No. 891.—SCOTLAND—EAST COAST.

Peterhead—Alteration in Harbours.

Particulars.—The reproduction of portions of Chart No. 1438, given below, show the alterations which have been made in the depths by dredging, the reconstruction of the piers, and the positions of lights in Peterhead Harbours.

LARGE SCALE.

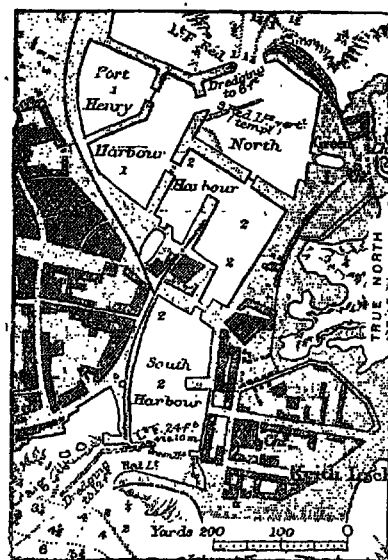
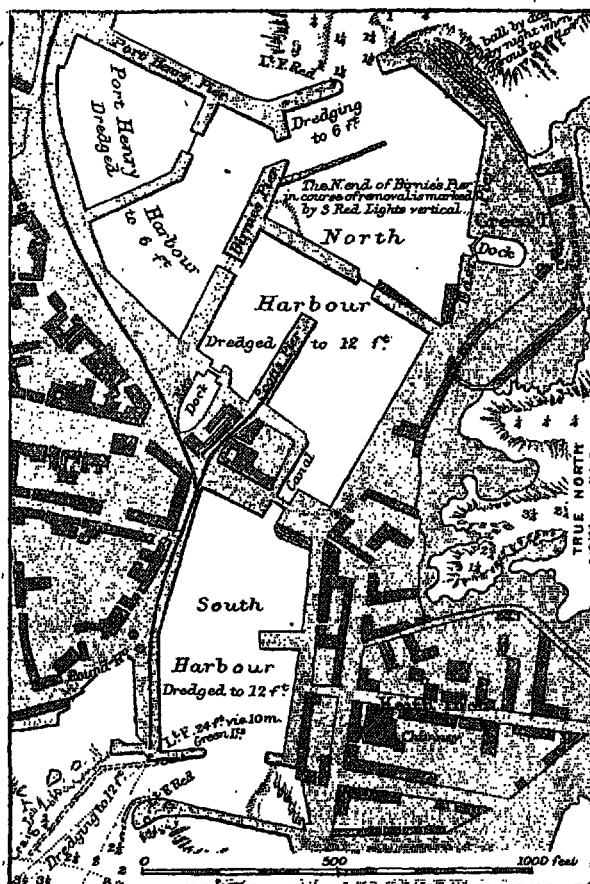
Caution.—The greatest caution must be exercised in passing the submerged position of Birnie's Pier.
